AGENDA FOR REGULAR MEETING VILLAGE OF TINLEY PARK PLAN COMMISSION

October 5, 2023 – 7:00 P.M.
Council Chambers
Village Hall – 16250 S. Oak Park Avenue

ITEM #1 WORKSHOP – SPLISH SPLASH CAR WASH – 7130 171st STREET – SPECIAL USE, VARIATION, FINAL PLAT, PLAT OF DEDICATION, SITE PLAN/ARCHITECTURAL APPROVAL

PLAN COMMISSION STAFF REPORT

Drawing
PROPOSED
ARCHITECTURAL
SITE PLAN

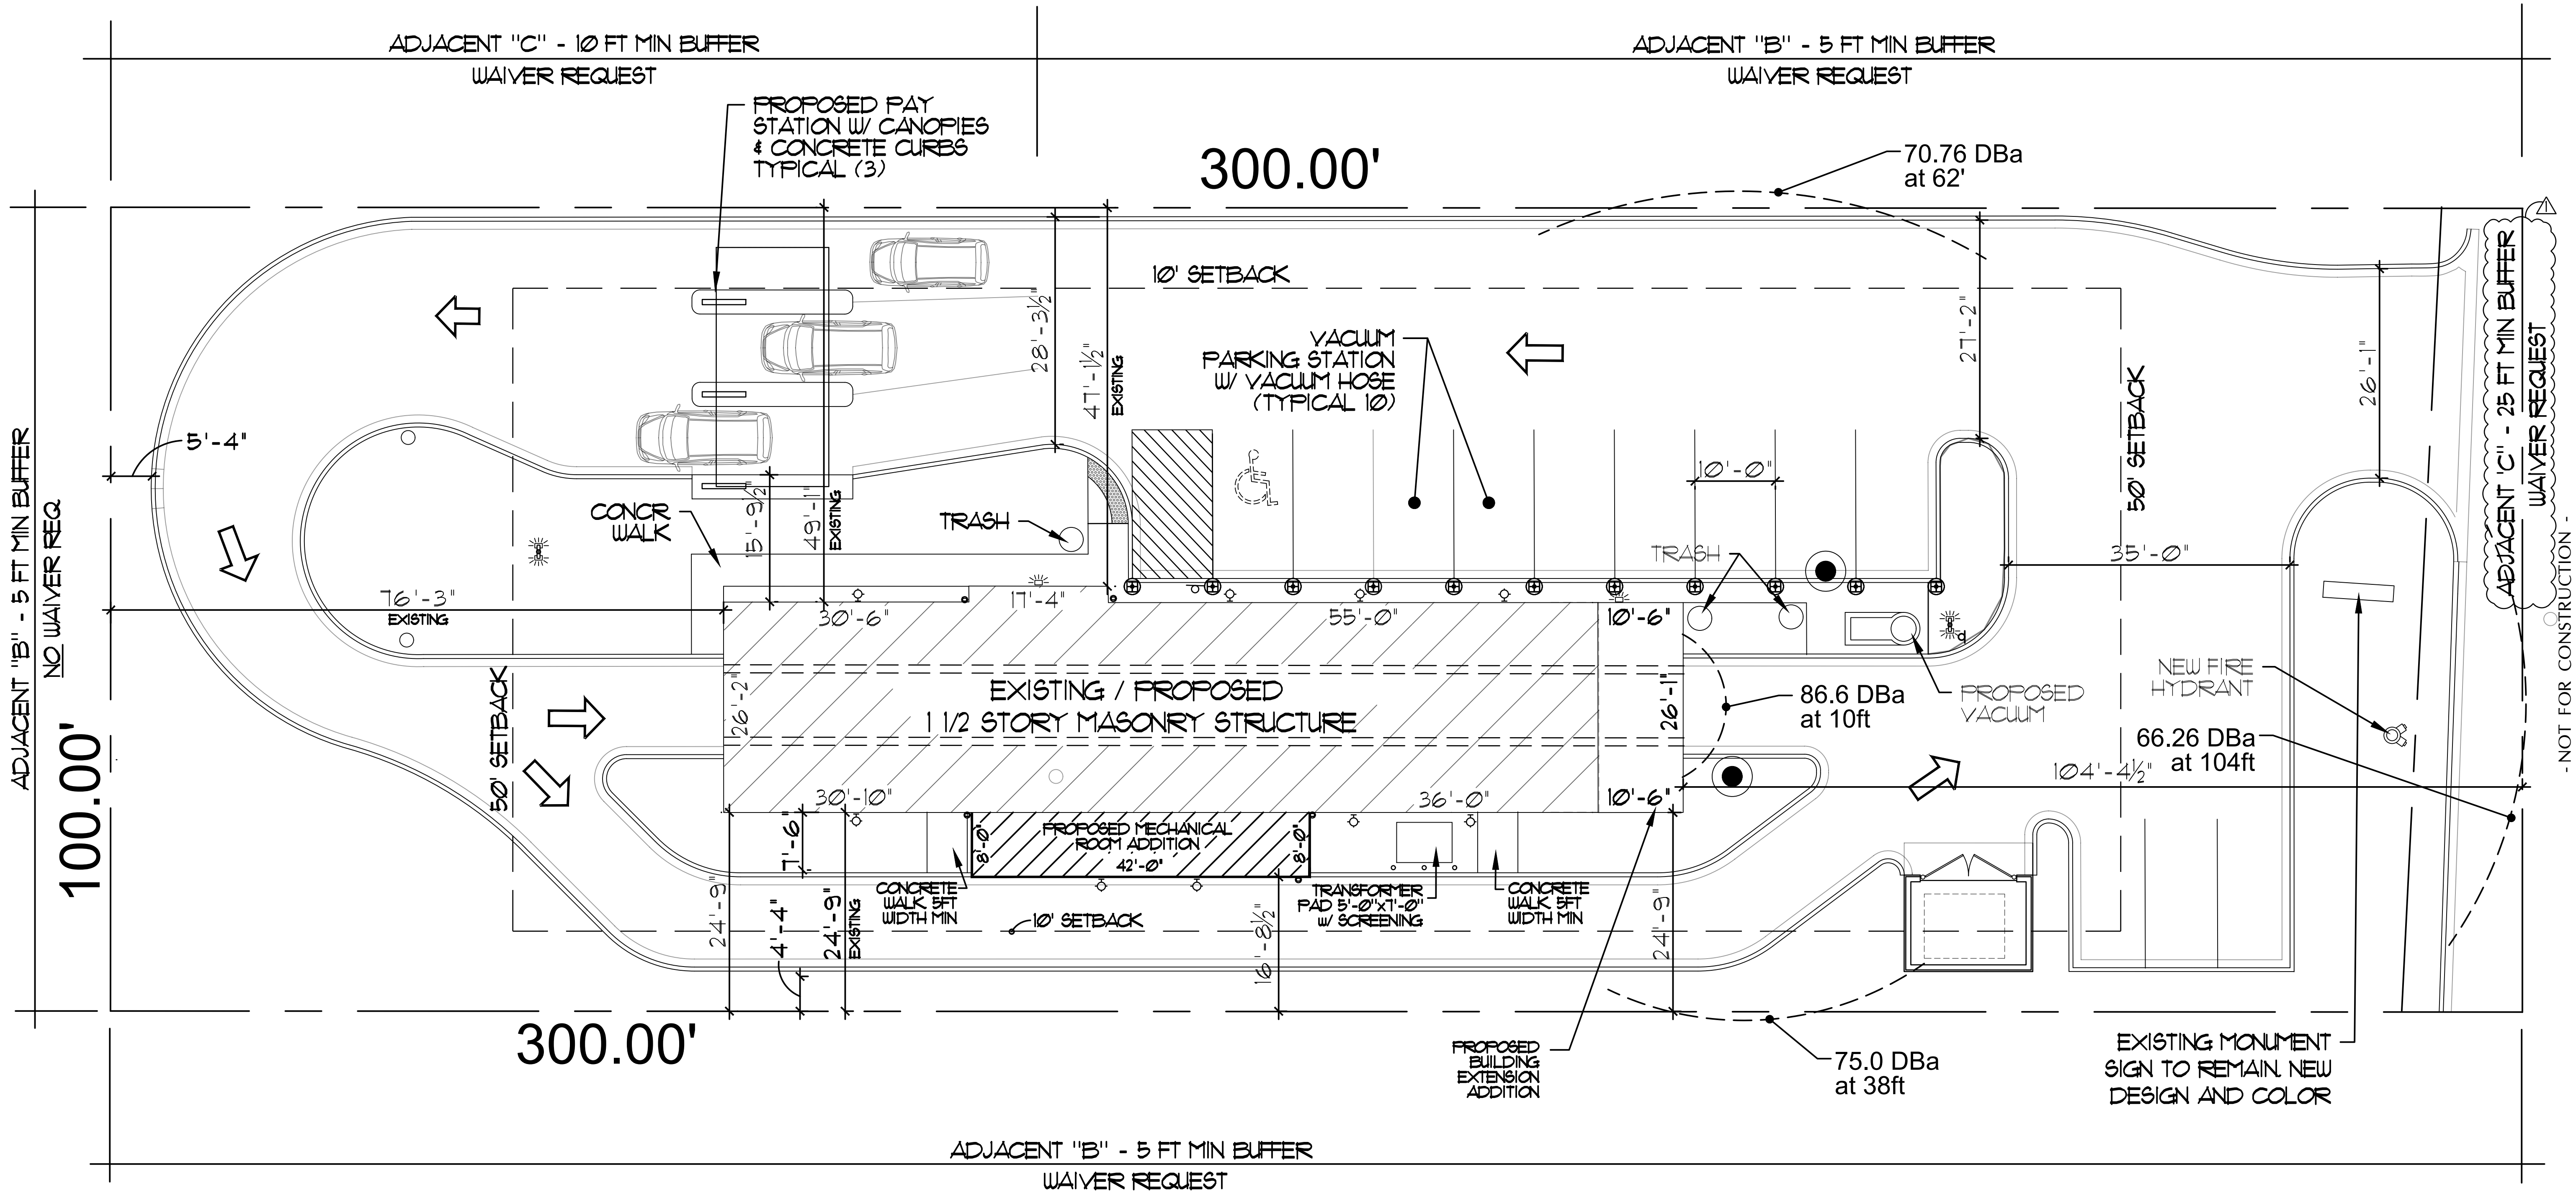
The building will have two additions, with a proposed building footprint of 3,442 sq. ft. and two stories. The height will minimally increase from existing 27'-6" to 28'-6" (per the Bulk Regulations table in the architectural site plan). This complies with the Zoning Code's maximum allowances of 35 ft. height and 3 stories. The west addition (for

The proposed site plan provides twelve total parking spaces (however listed as 13 on the architectural site plan's Parking Calculations table). There will be nine vacuum stalls, eight of which are standard, and one as an accessible stall plus an access aisle. Three stalls are also currently proposed at the southwest area of the site. The Petitioner identified that two employees plus a manager will be on-site. Zoning Code requires one space for each employee (*per the related use of an Automobile Service Station*).

PROPOSED PHOTOMETRIC SITE PLAN

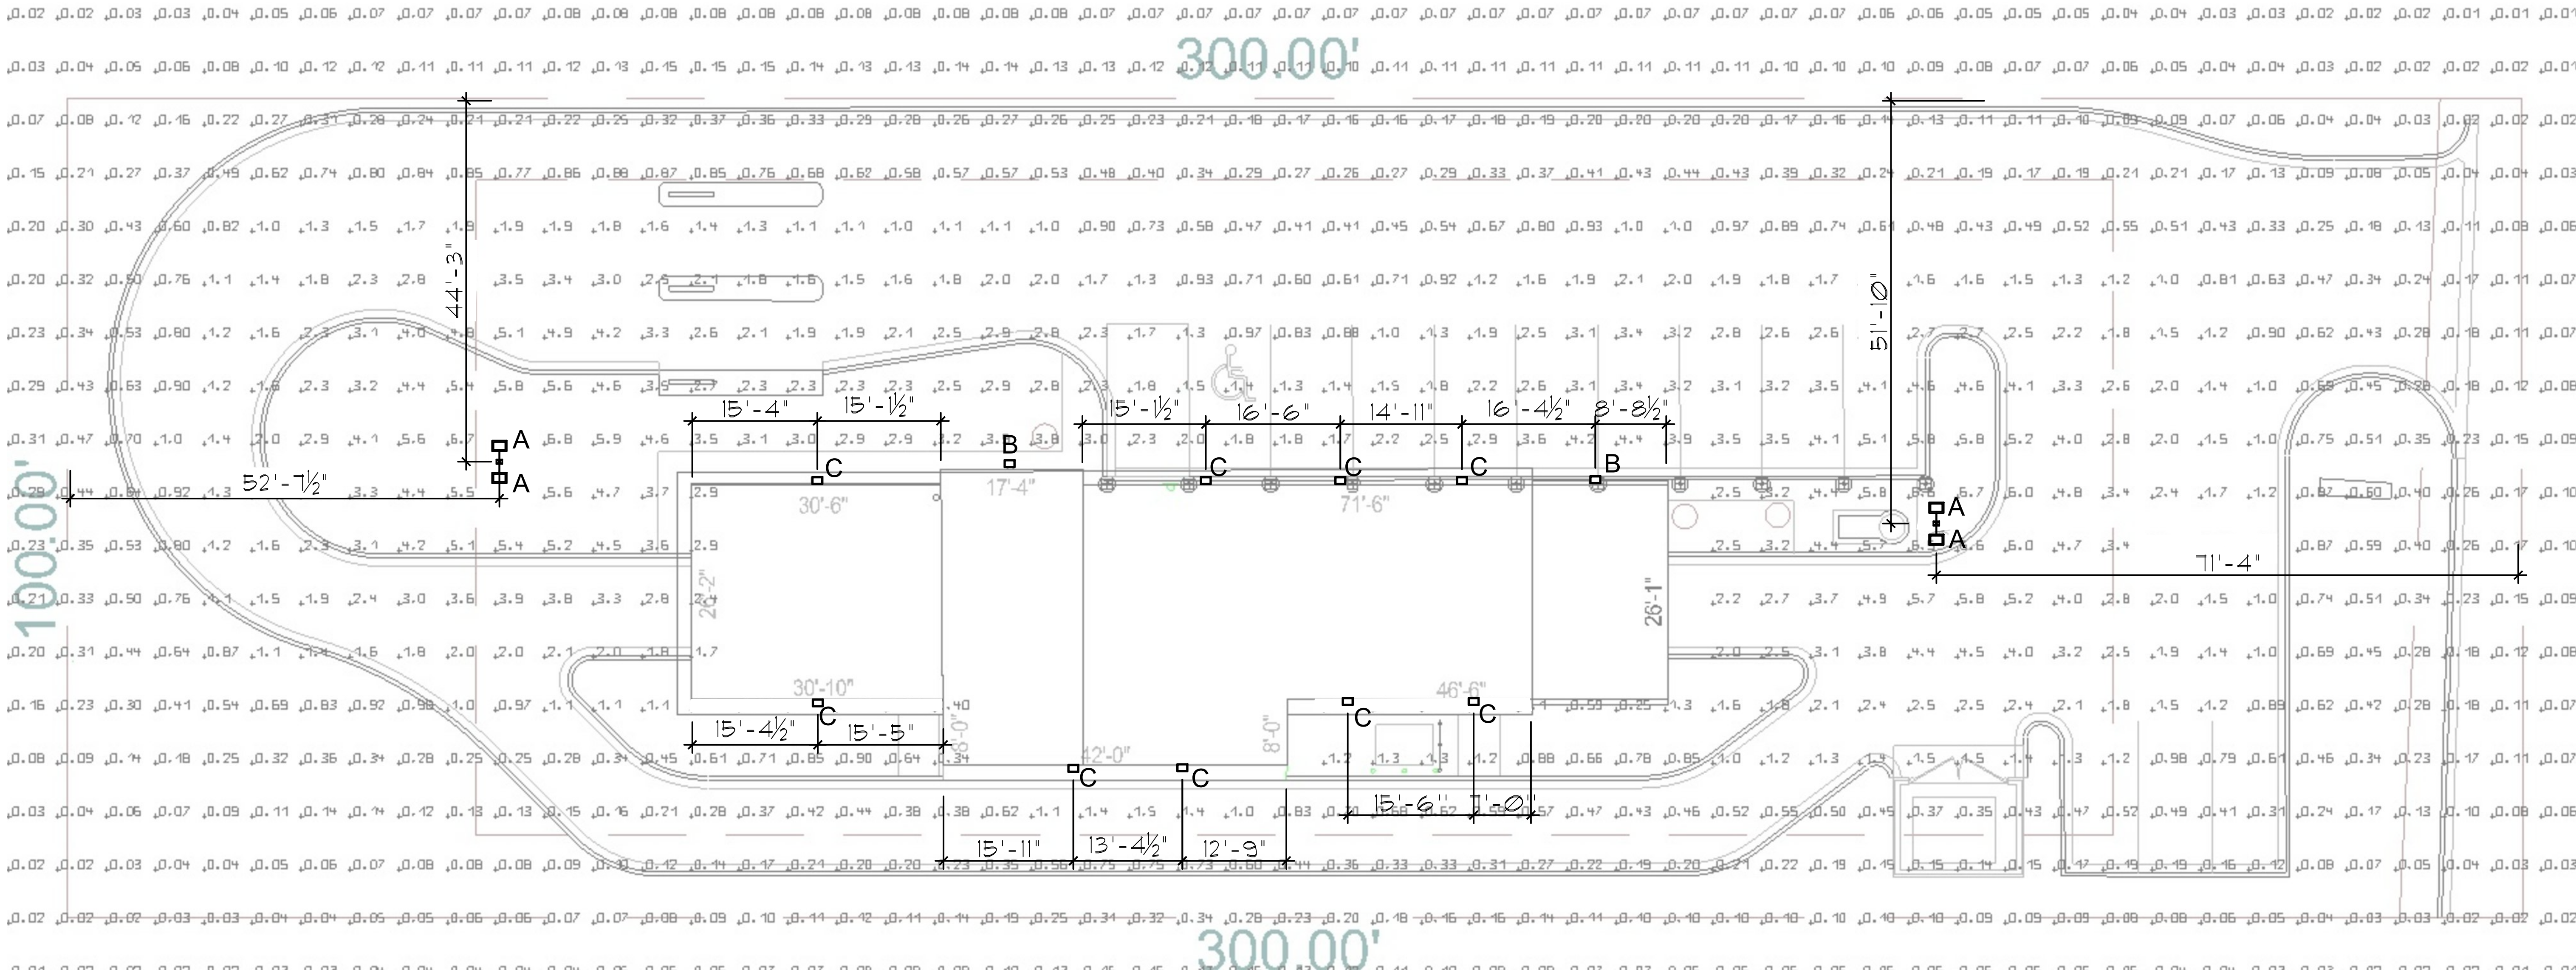
The Petitioner proposes three types external lights. The proposal meets the Zoning Code's maximum 2.0 foot candles (horizontal) requirement at the property line. The Petitioner has stated all light fixtures (building and parking area) will have no uplight (rating U0) with no light above a 90 degree plane. The lighting fixtures are noted below and meet Zoning Code glare requirements:

- Two light poles with two fixtures each are proposed (Type "A"); one south of the building near the vacuum motor, and the other north of the building. The mounting height will be 25 feet.
- Two wall pack fixtures are proposed on the upper portion of the east side of the building (Type "B"). The northerly one is proposed as mounted 22' high, and the southerly is proposed as 20' high. Zoning Code Section V.3.1. states "*floodlighting and wallpack lighting fixtures are discouraged, and if used, shall be rated U0. . . with no light above a 90 degree plane to prevent disability glare for drivers or pedestrians and light trespass beyond the property line*". Though wallpacks are discouraged, they are located toward the middle of the site. The Petitioner will need to confirm the package

specifications at time of permitting; the 90CRI specification on the lighting schedule is not listed as an option in the manufacturer’s spec sheet, and the finish color is not selected.
